**Technical Service
BULLETIN**

Title:
SLIDING DOOR RATTLE

Models:
'04 – '06 Sienna

REVISED
NV001-06
NVH

Part Location

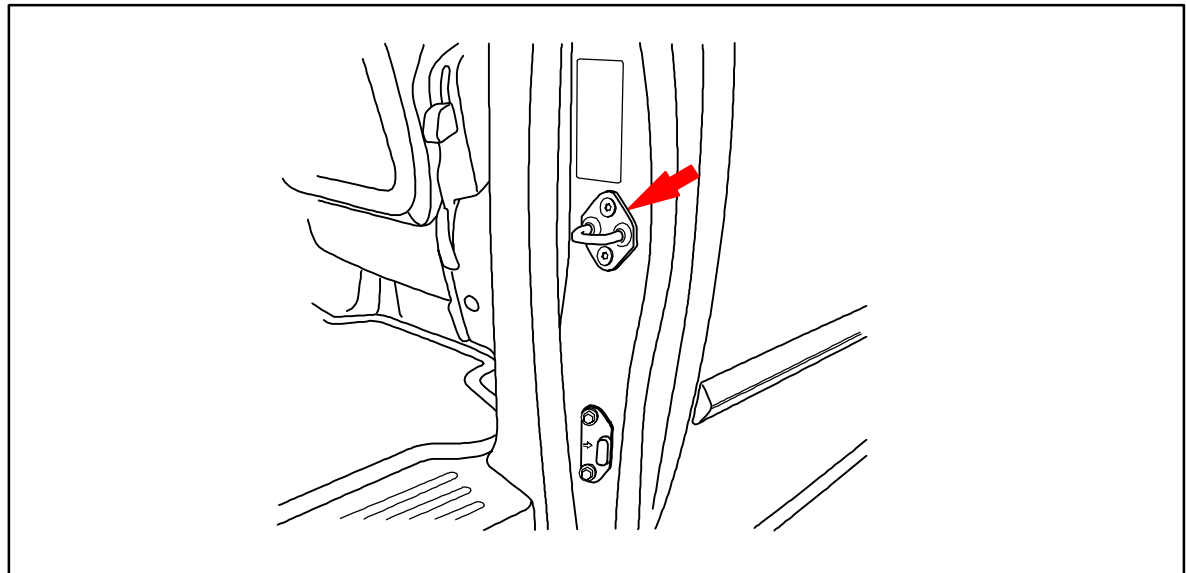
Introduction The sliding door front striker plate and lock assembly on 2004 – 2006 model year Sienna vehicles have been redesigned in order to address customer complaints of rattles that occur under certain driving conditions. The improved front striker plate and lock assembly have a new coating that will reduce noise from contact between the front striker plate and the sliding door lock assembly when in the closed position.

- Repair Procedure 1** For vehicles produced BEFORE the Striker Plate Production Change Effective VINs, remove and replace the front striker plate and lock assemblies on both slide doors.

- Lock Assembly Torque: 5 N•m (51 kgf•cm, 44 in.•lbf)**
-
- Repair Procedure 2** For vehicles produced AFTER the Striker Plate Production Change Effective VINs and BEFORE the Lock Assembly Production Change Effective VINs, remove and replace the lock assemblies on both slide doors.
